## End Insulators for DCA310

TS-SSC 91-107  
S. Delchamps  
June 5, 1991

Figure 2a.

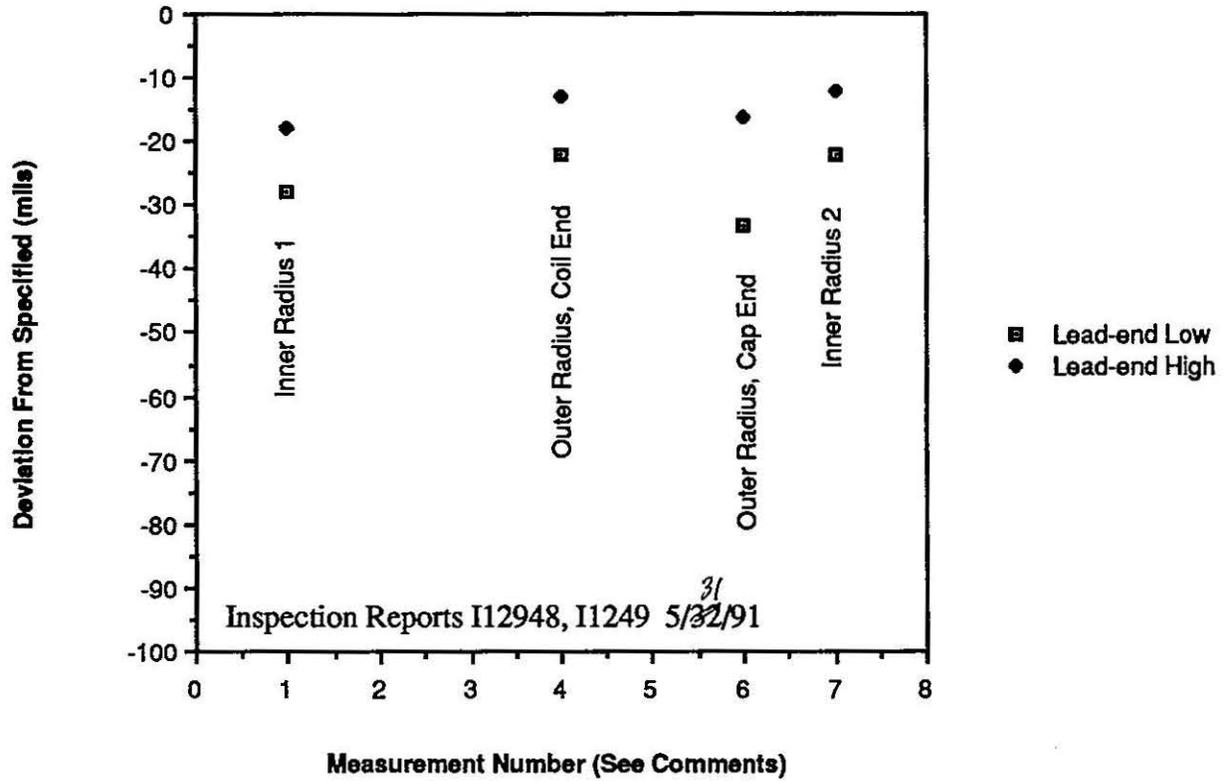
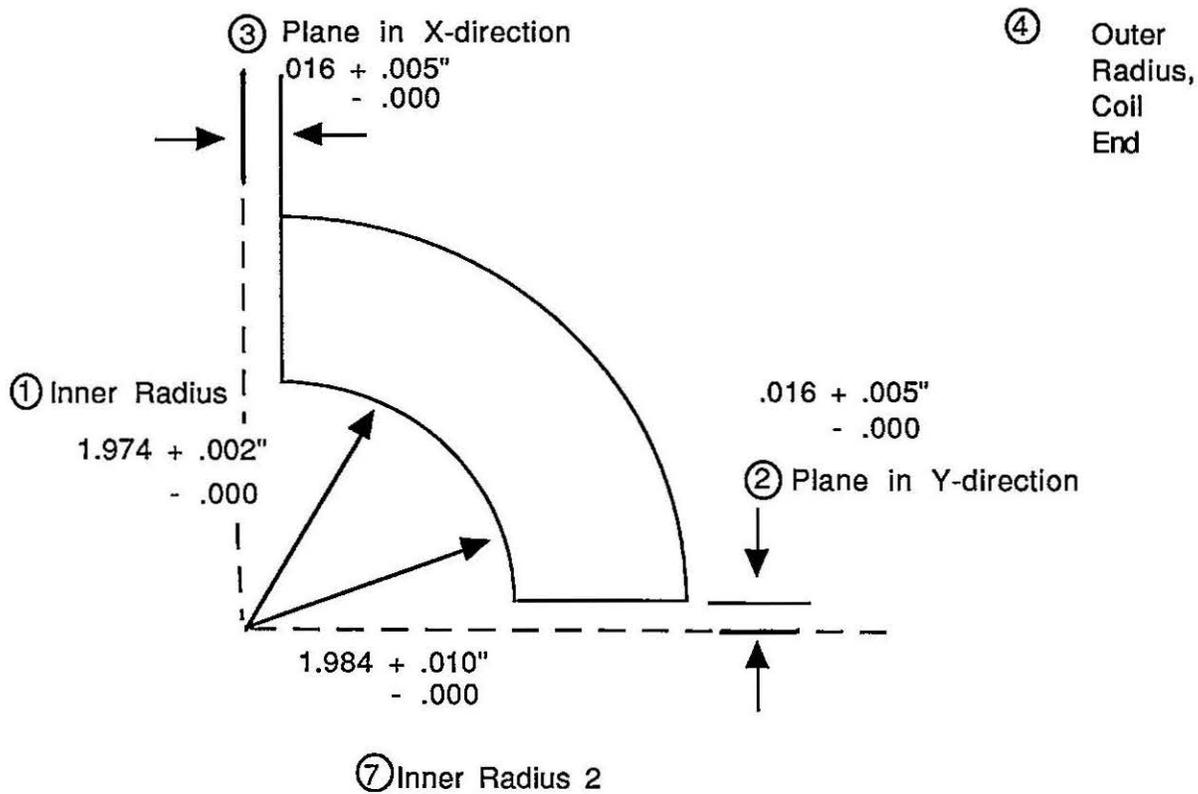
**Inner and Outer Radii:** Figures 2a and 2b show the deviations in mils from the specified values of all radius measurements. These measurements are seen to be consistent with a fairly uniform "bowing" of the part, which has been seen before in G10-CR end insulators. This bowing is expected, since the four insulator quadrants are cut from a cylinder with the correct dimensions<sup>1</sup>, thereby allowing built-in stresses to relax. The uniformity of the radius decrease from inner to outer radii implies that the parts have the correct thickness.

**DISPOSITION:** Since the bowing of the parts will probably disappear upon installation, I recommend going ahead with installation of these parts. We might consider cutting radial grooves in the parts to allow them to conform more easily. This has been recommended on several occasions by John Carson, but I have never tried it.

Figure 1.

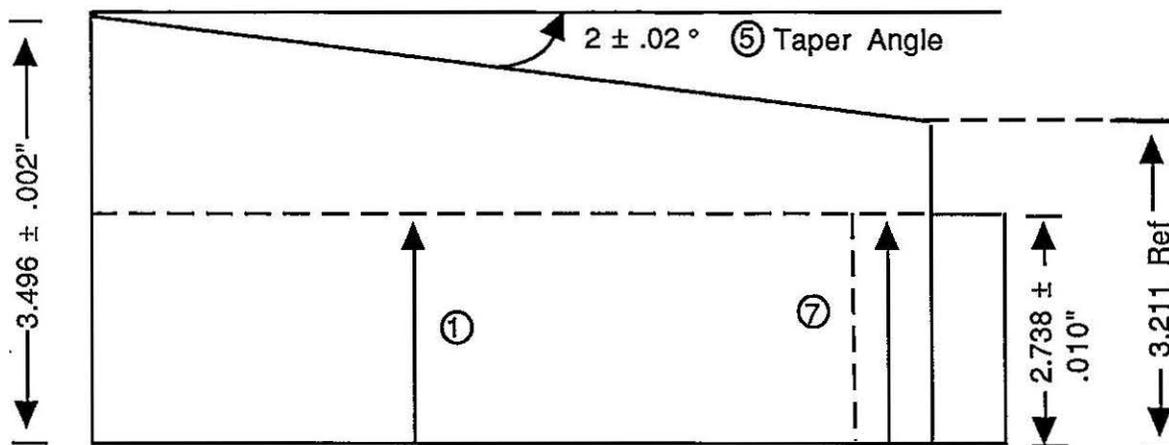
Inspection reports I12940, 12946, 12948, and 12949 give Cordax measurement results for G10-CR lead and non-lead end insulators to be used in magnet DCA310. Figure 1 shows schematically which measurements are found to be out of tolerance. These measurements and their minimum and maximum deviations from specified values are given in Table 1. The first column of the table gives the specified tolerance range for each of these measurements.

**Taper Angle:** The range of deviations from desired taper angle implies a range in the difference between reference dimension 3.211 inches and the dimension 3.496 inches (see Figure 1) of + 9, -15 mils. It is not immediately clear to me what should happen to this taper angle when the insulators bow in.

I would like to understand the taper angle issue better. The specified range in taper angle ( $\pm 0.02$  degrees) implies a  $\pm 4.9$  mil range in the 3.211" reference dimension if the  $\pm 2$  mil tolerance in the 3.496" dimension is taken into account. I don't know what the taper angle tolerance should be.
